Docket Item #2

Development Special Use Permit #2012-0009
Alexandria Toyota Extension – 3750 Jefferson Davis Highway

Purpose of Application: Request a three-year extension of a development special use permit (DSUP #2007-0034) to construct an automobile detail building and install auto lifts.

Tower 203 Turning Specifications:

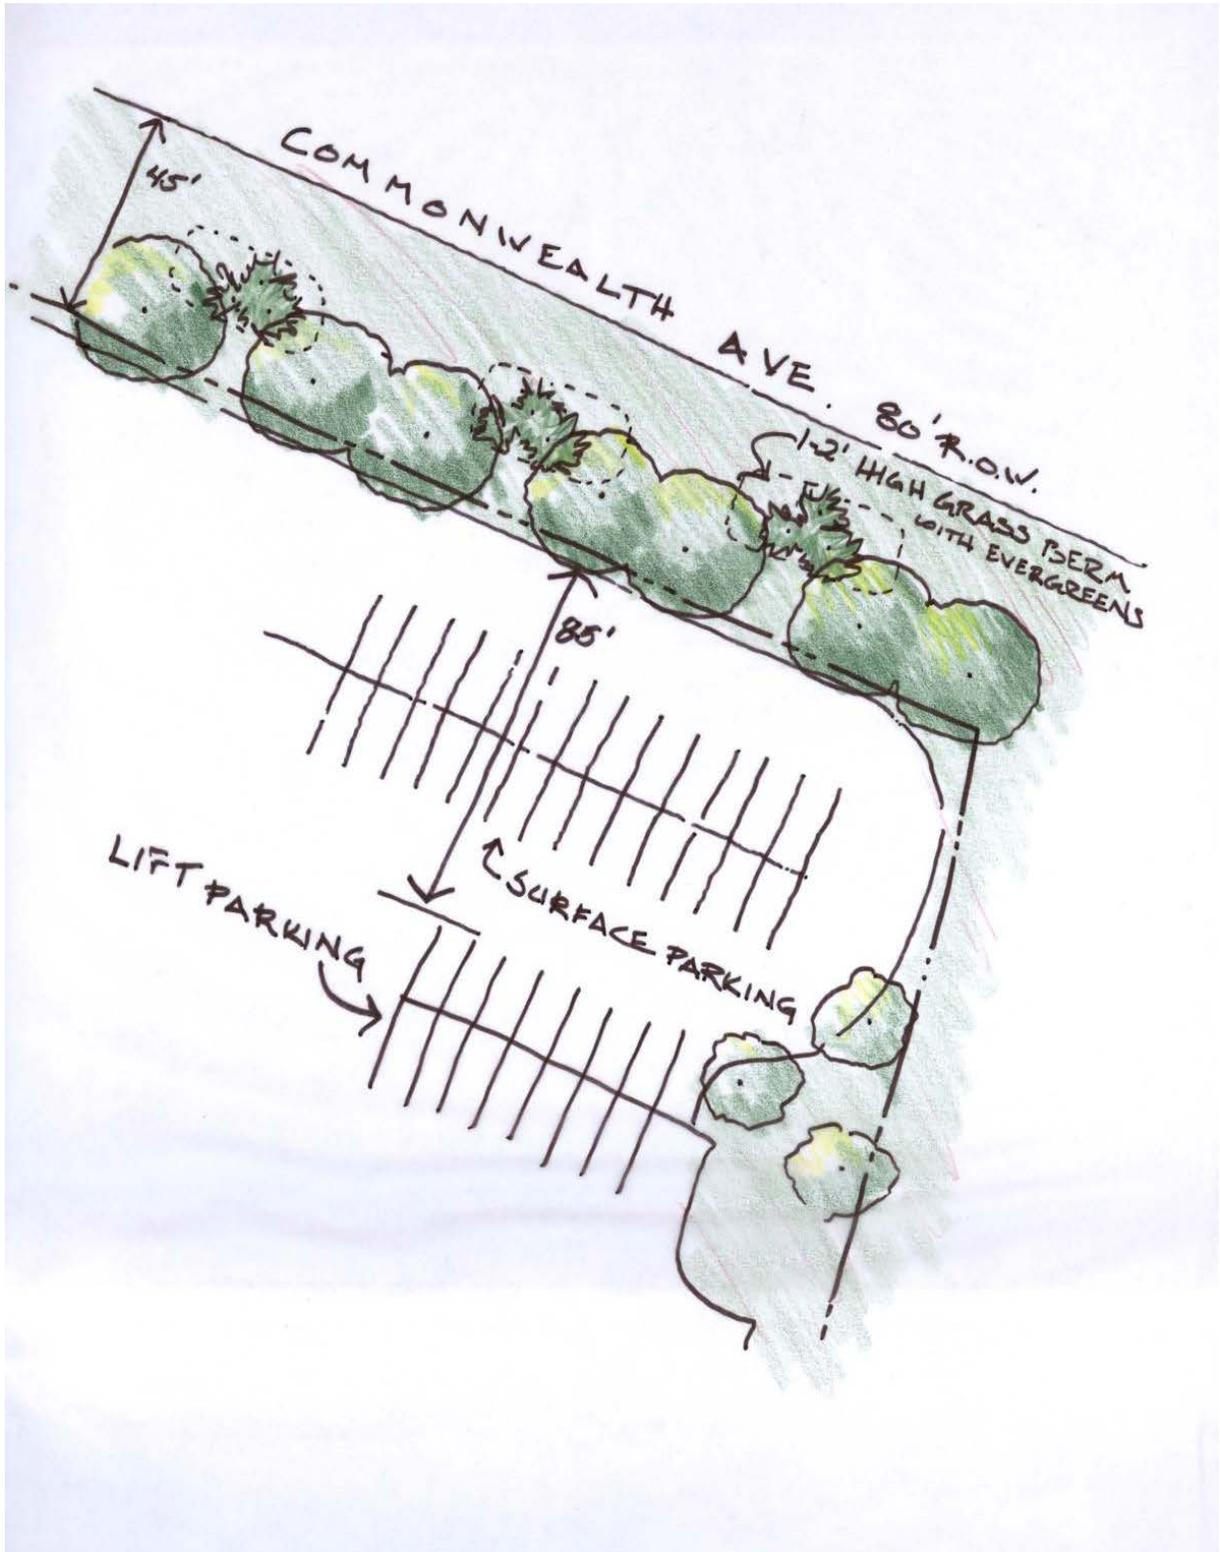
C - 7. **CODE REQUIREMENT ADDED BY STAFF:** Show fire apparatus vehicle turning radius based on the following specifications:

- a. Turning Radius:
 - i. Wall to Wall = 54.98 feet + / - 2 feet
 - ii. Curb to Curb = 51.33 feet + / - 2 feet
 - iii. Inside turning radius = 37.73 feet + / - 2 feet
- b. Overall Length – 47' – 4 ½"
- c. Overall Width – 98"
- d. Wheel Bases from front axle to both rear axles – 240"
- e. Tandem axle spacing – 56" CL of axle to CL of axle
- f. Gross Weight – As built with no equipment or water gross weight = 66,000#
- g. Angle of Approach – 13 Degrees
- h. Angle of Departure – 11 degrees
- i. Ramp Break Over – Break over angle is 9°

Figure 7 Staff Recommended Landscape Along Commonwealth Avenue

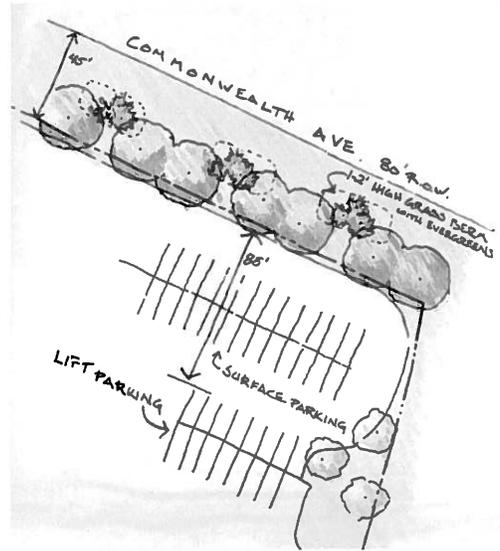
6. **CONDITION AMENDED BY STAFF:** The applicant shall provide a landscape design along the entire Commonwealth frontage as generally depicted in Attachment #1 and shall be designed and installed and to the satisfaction of the Directors of P&Z and RP&CA. The plan shall include:
